Our Ref: PM/5646 25th March 2024

RE: RECONSTRUCTED OUTBUILDING, OLD TONG FARM, TONG ROAD, BRENCHLEY

Plate 1 – Internal View of Roof Structure

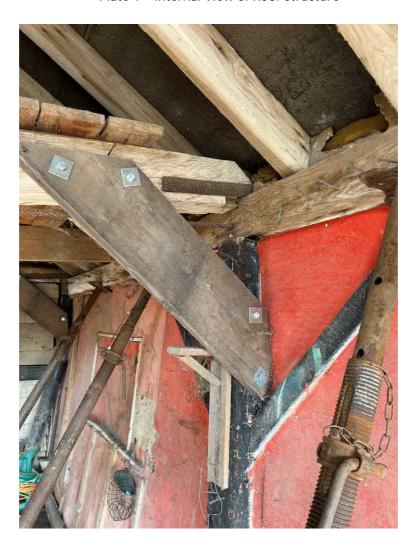
The outbuilding is detached and comprises a pitched gabled roof with clasp purlins (see plate 1 at the rear of this letter report). The rafters are approximately 80x90mm deep at 450mm centres that span from the eaves plate to a thin ridge board and are supported along their length by 130mm wide x 110mm deep purlins. The purlins are generally supported by horizontal collars on the main frame locations, although no collar is present to truss 4 (refer Anthony Hicks drawings for grid references). Diagonal bracing timbers were present to the underside of the rafters.

Our preliminary calculations indicate that the existing rafters, purlins, collars, eaves plates and the internal tie beams are all adequate so we are of the opinion that all of these elements can be retained. The lack of collar on truss 4 can be rectified by installing a

replacement horizontal collar or by two vertical posts onto the tie beam below. Minor movement was noted to the connections between the tie beams and eaves plate and the existing straps are minimal, so we would recommend that these joints are supplemented with more substantial traditional steel twisted blacksmiths straps (60x10mm thick x min 750mm long).
